Final
Remedial Investigation
Work Plan
for
Area of Concern (AOC) R
at the

Former U.S. Naval Ammunition Support Detachment (NASD)
Vieques Island, Puerto Rico

Prepared for
Department of the Navy
NAVFAC ATLANTIC

November 2005

Figure 1-3
Aerial Photography, AOC R
Former NASD, Vieques, Puerto Rico

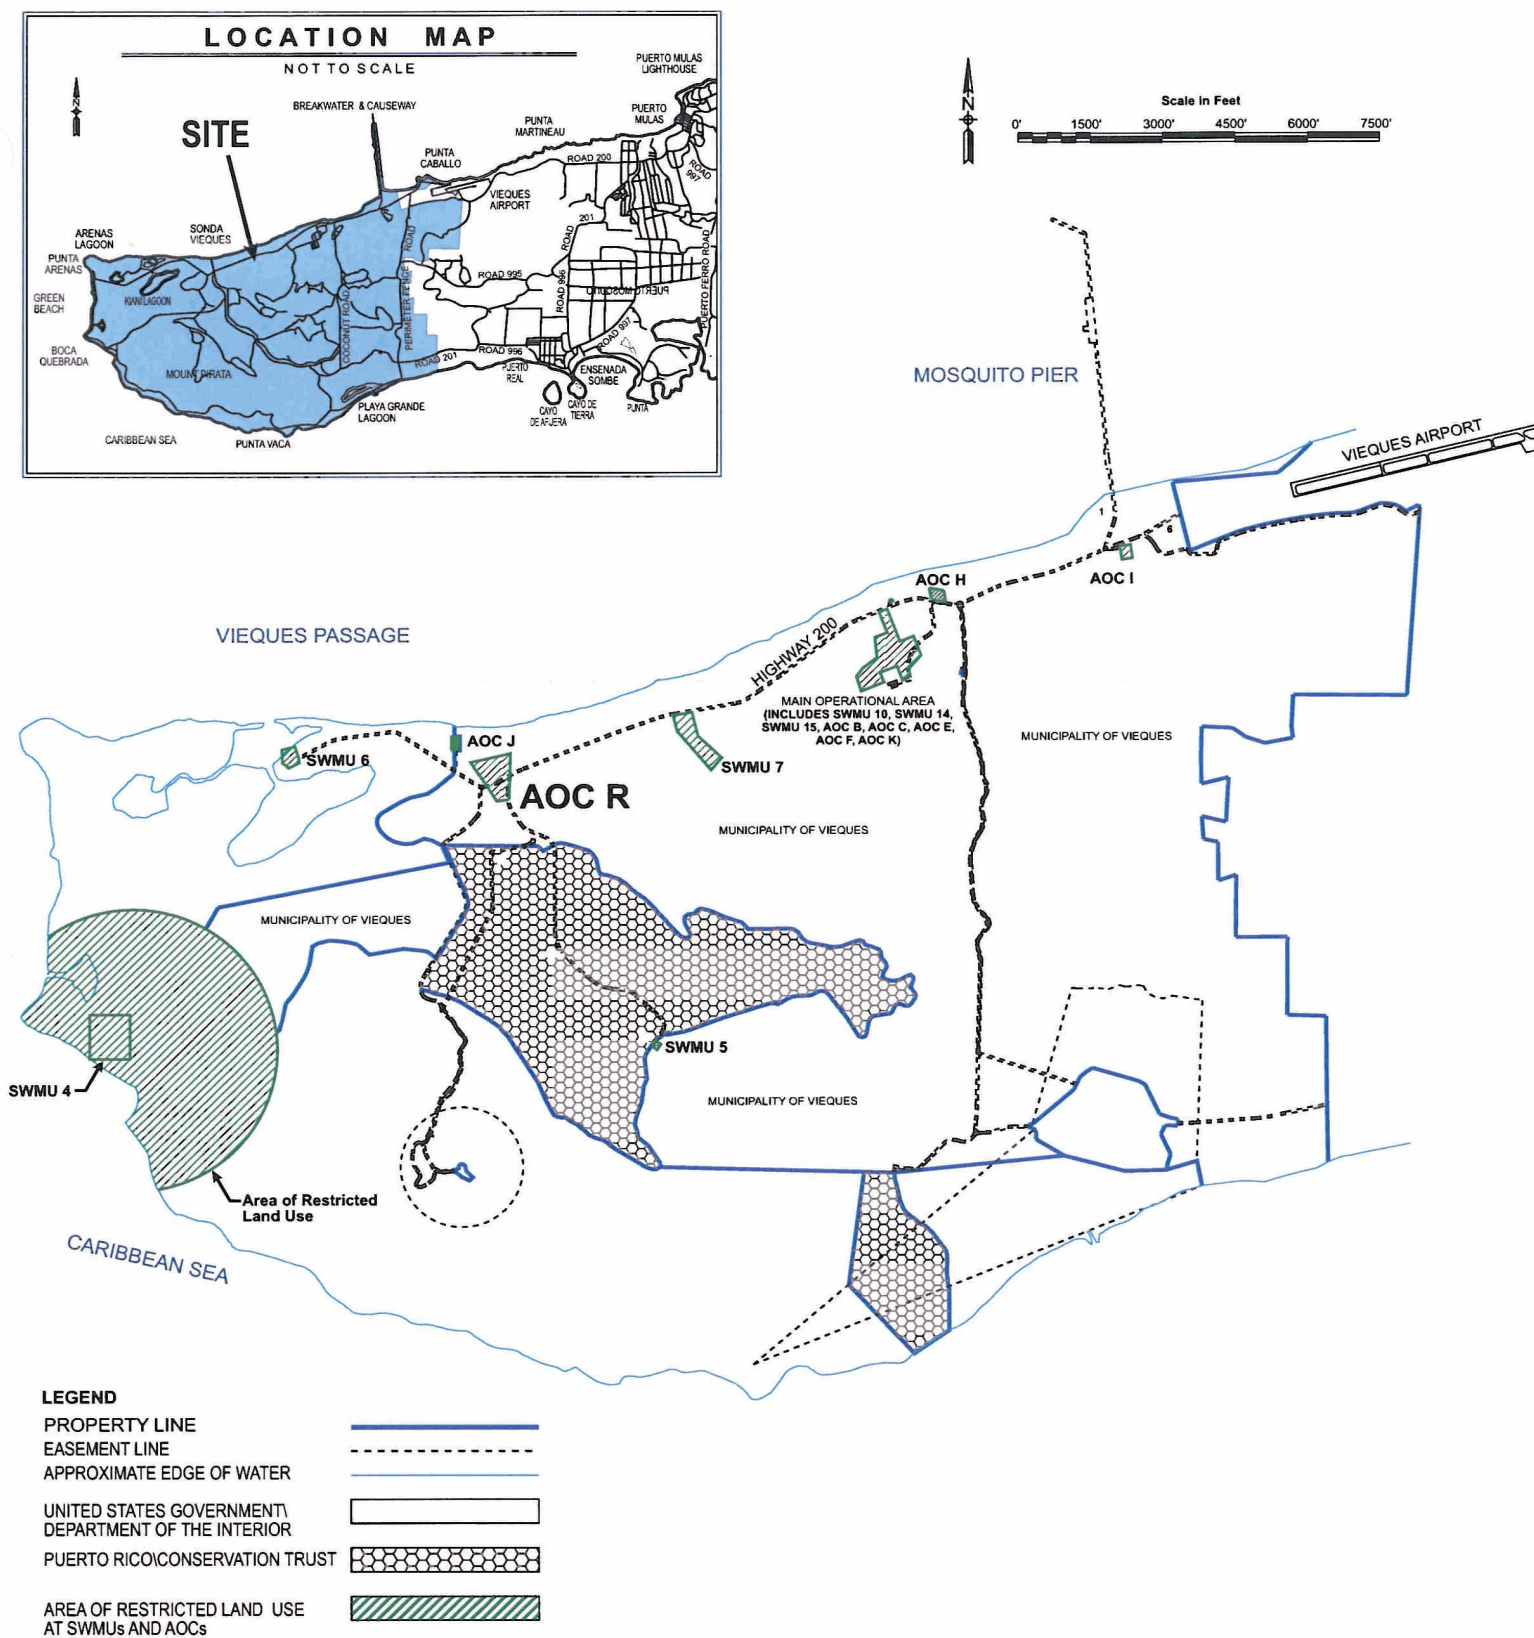
- 6) In our previous letter we mentioned an additional structure which may or may not be related to the site. This is the building in Figure 1-3 that is seen north of the access restriction boundary. This question has been asked by both the agencies and the TRC.

Figure 2-2
Location of AOC R, Former Construction Staging Area Site within the
Former NASD, Puerto Rico
Former NASD, Vieques, Puerto Rico
 Source: Expanded PA/SI Seven Sites report, 2002

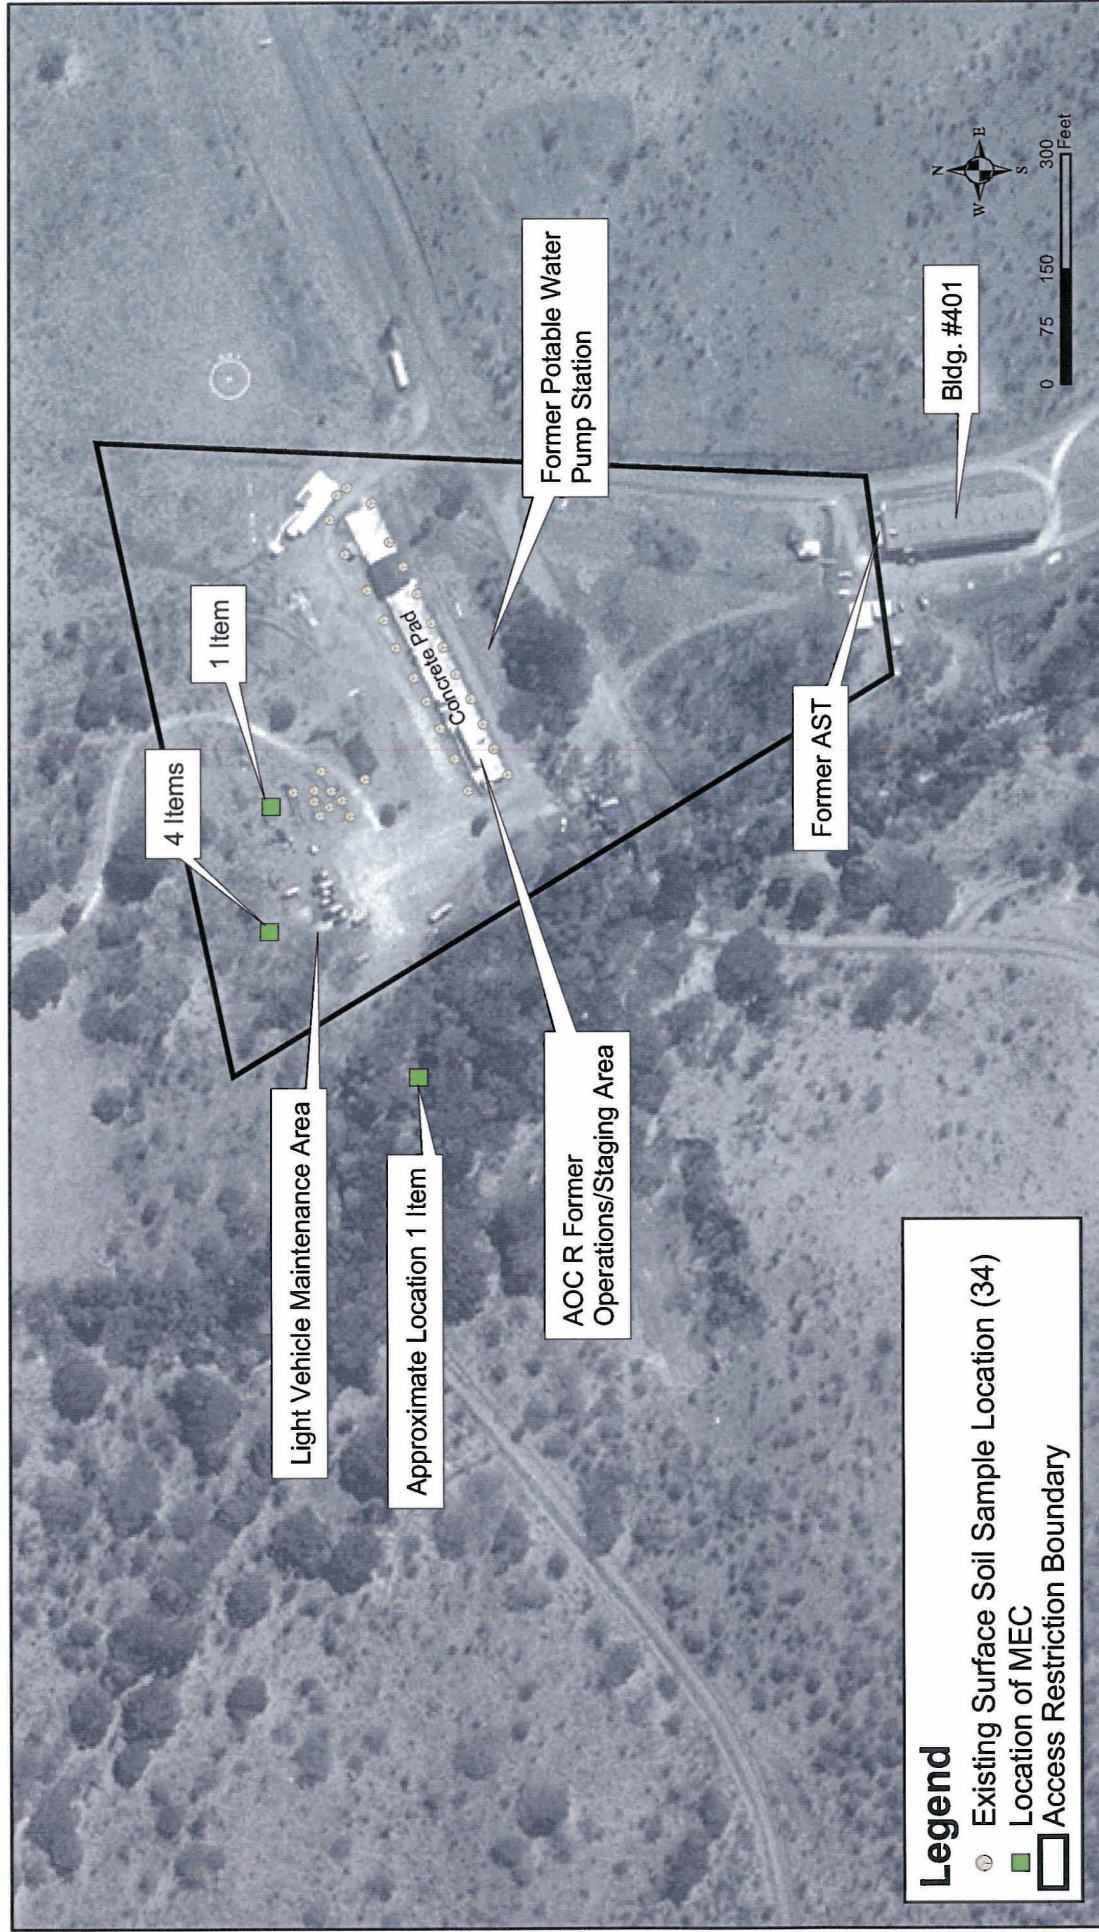
- 5) In order for reviewers to understand the relationship between the two AOC sites, AOC J should be shown in Figure 2-2 of the document.

Figure 2-2 will be revised to show the location of AOC J. In addition, surface water and sediment samples collected at AOC J will be shown in Figure 4-1, making note that they are existing (not proposed).

Figure 4-1
AOC R Surface Soil, Subsurface Soil, Surface Water, Sediment, and Groundwater Sample Locations.
Former NASD, Vieques, Puerto Rico.

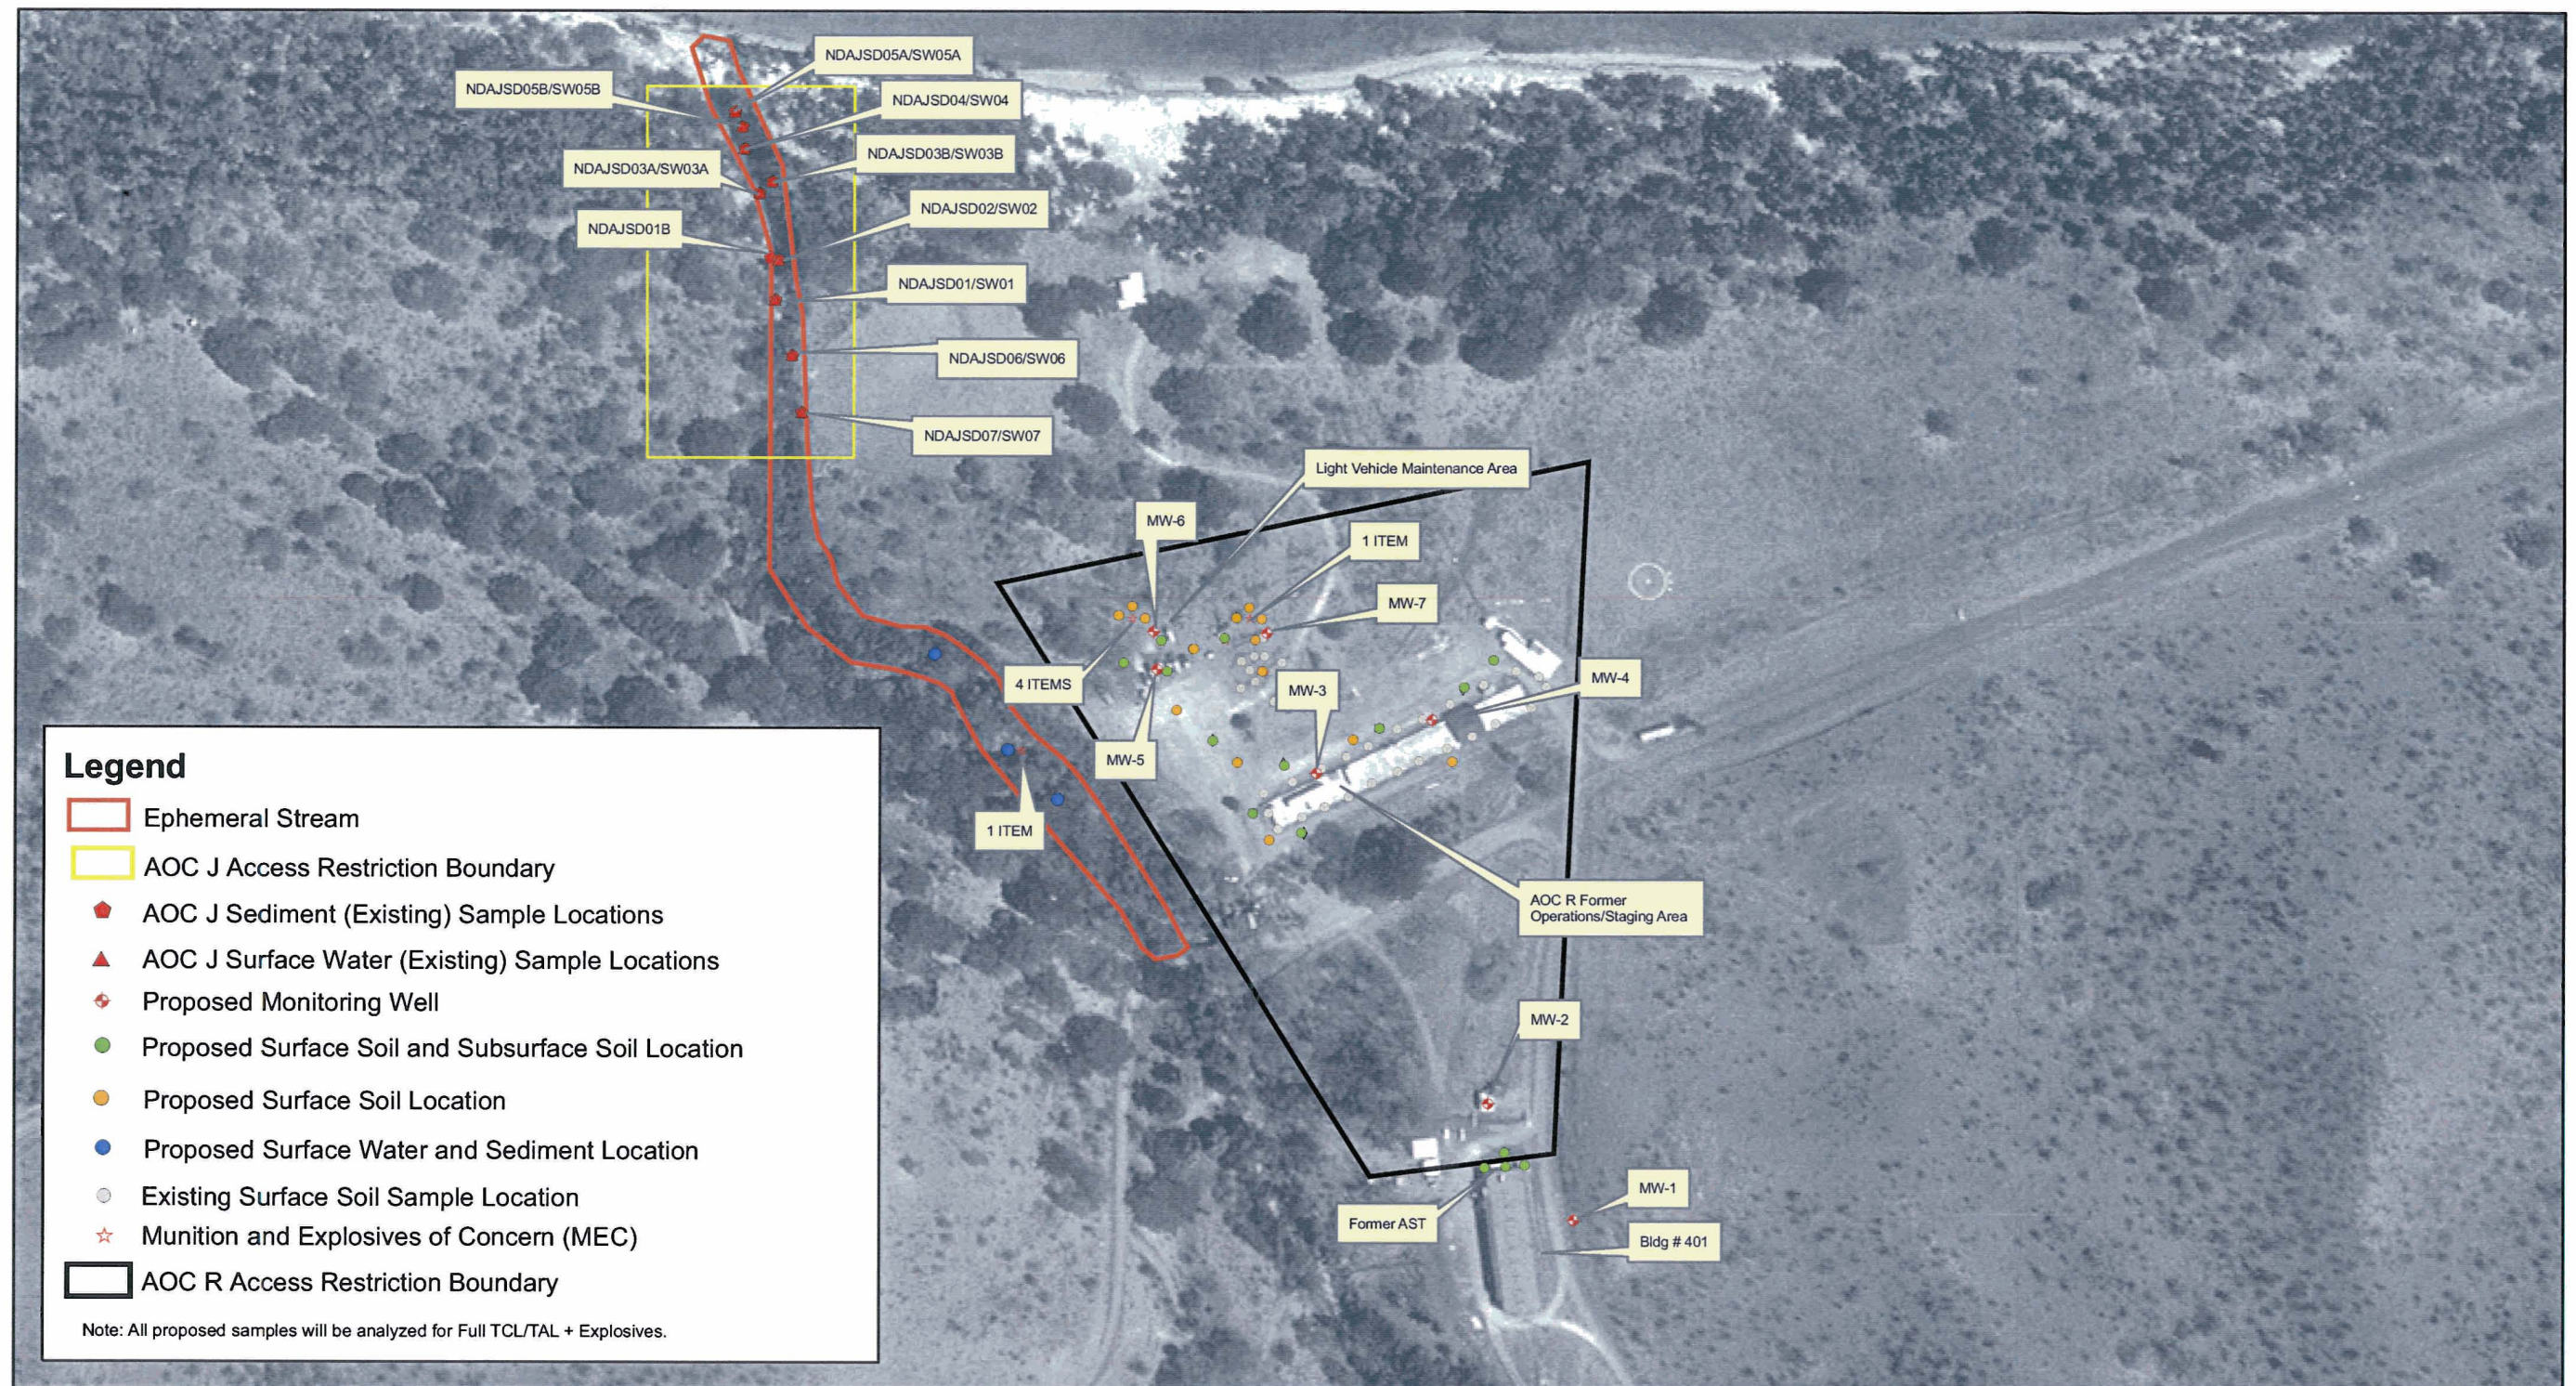
26. Figure 4-2, AOC R Surface Soil Sample Locations: The ephemeral stream should be clearly identified in this figure. It is indicated in Figure 2-4 that there is an MEC area to the west of the site. Additional surface soil samples will be collected from this area (Figure 4-2). These sample location should be numbered as appropriate. As there is an ephemeral stream in this area, surface pathways to the stream from this area should be sampled, as appropriate.

27. Figures 4-2 and 4-3: The keys on the figures do not match the text or Table 4-4. It is presumed that the text and table is correct and the figure needs to be amended. The clarification is important in that it is not clear what analyses are intended.

It was noted that in Figure 4-2, the symbol for MEC sample locations needs to be revised to indicate explosives analysis.

Attachment 4: Revised Figure 4-1 (Proposed Monitoring Well and Sampling Locations). Note that all monitoring well and sample locations are shown on one figure because full TCL/TAL and explosives analyses have been concurred upon for all samples collected as part of this Work Plan.

The approximate ephemeral stream boundaries and the proposed sample locations have been added to revised Figure 4-1 (Attachment 4). An incorrect surface soil sample symbol was used for the samples around the MEC items in the original Figure 4-2.

The location of the former carpentry shop is unknown. There is no known former mechanics shop at the site. Figure 4-1 has been revised to re-locate the monitoring well locations.
